REMOVAL PLAN

PROPOSED PLAN

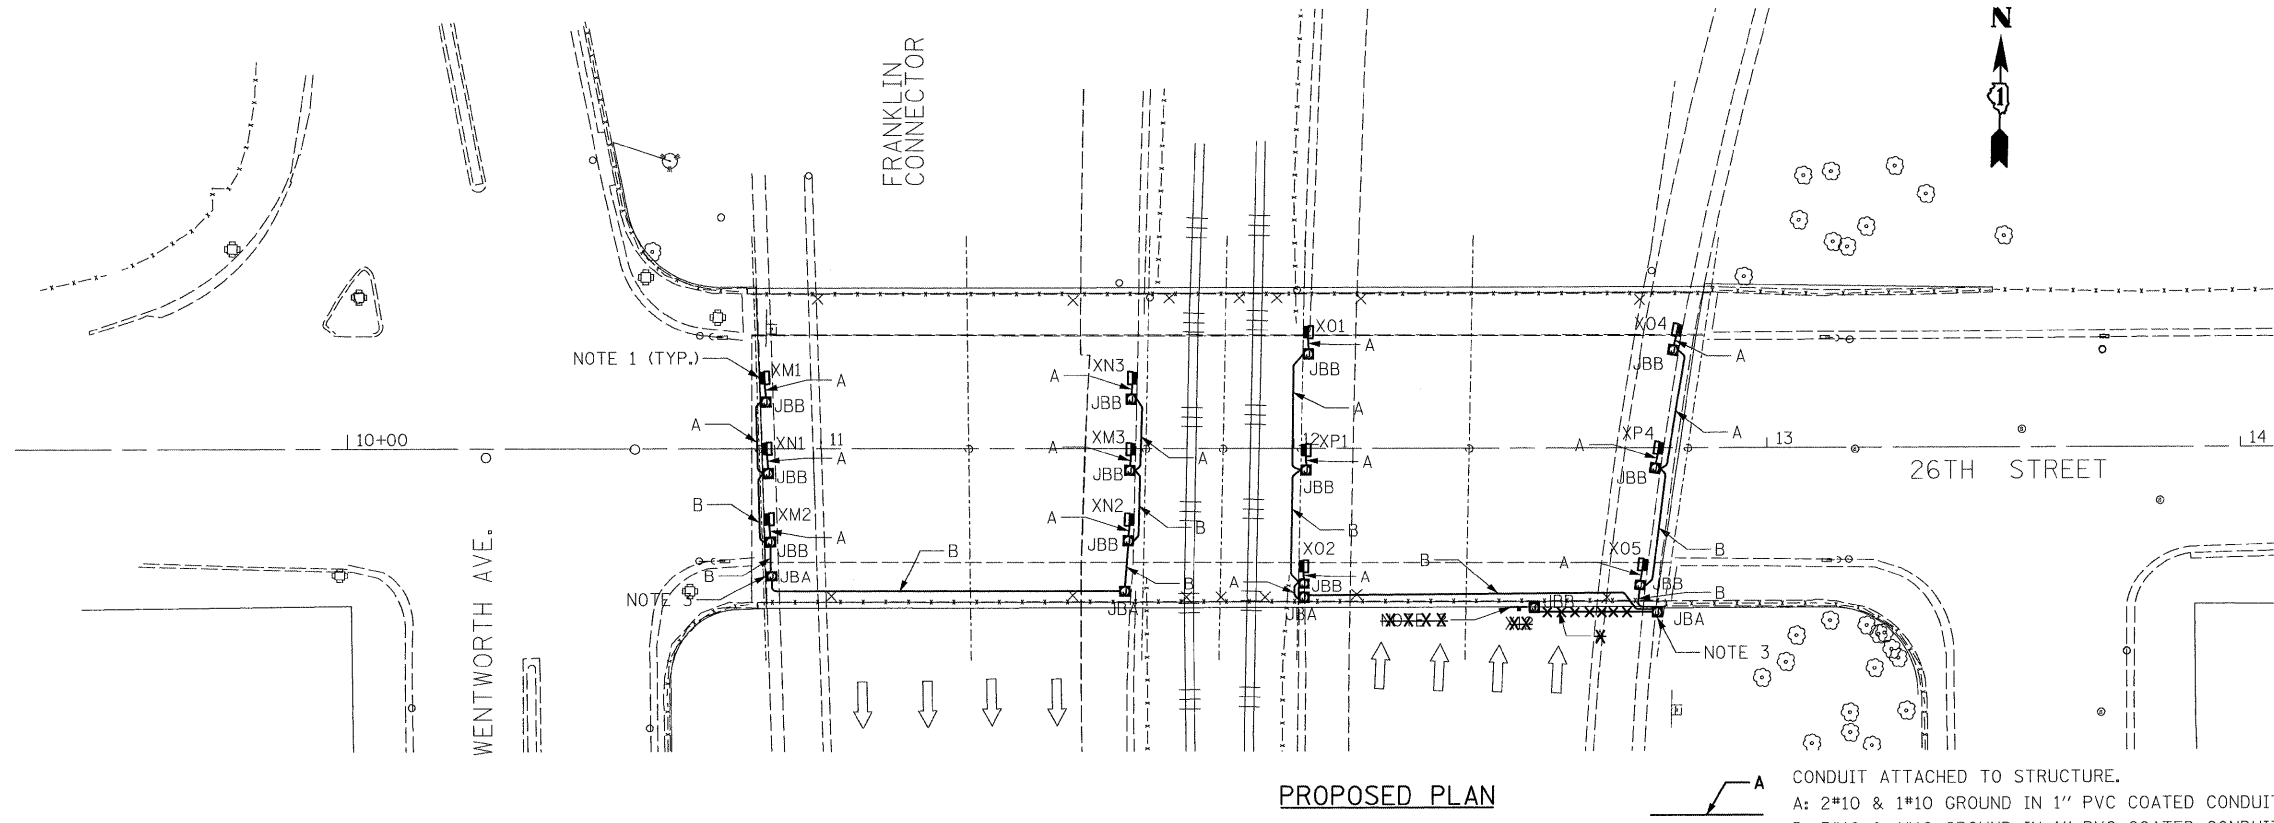
- PROPOSED NOTES
- 1 - PROVIDE NEW 150W HPS UNDERPASS LIGHTING. PROVIDE CONDUITS AND WIRES AS SHOWN. RECONNECT PROPOSED UNDERPASS LUMINAIRES TO EXISTING CIRCUIT AT ROADWAY JUNCTION BOX ON FRANKLIN CONNECTOR.
 - ~~2- RE-INSTALL ILLUMINATED ROADWAY SIGN.~~
 - 3- PROVIDE NEW CONDUIT FROM CONDUIT RISER POINT AT GRADE TO JUNCTION BOX. SEE DETAILS FOR MORE INFORMATION.
 - 4- ALL PROPOSED CONDUIT AND CABLE SHALL BE AS PER LEGEND SHEET E1.
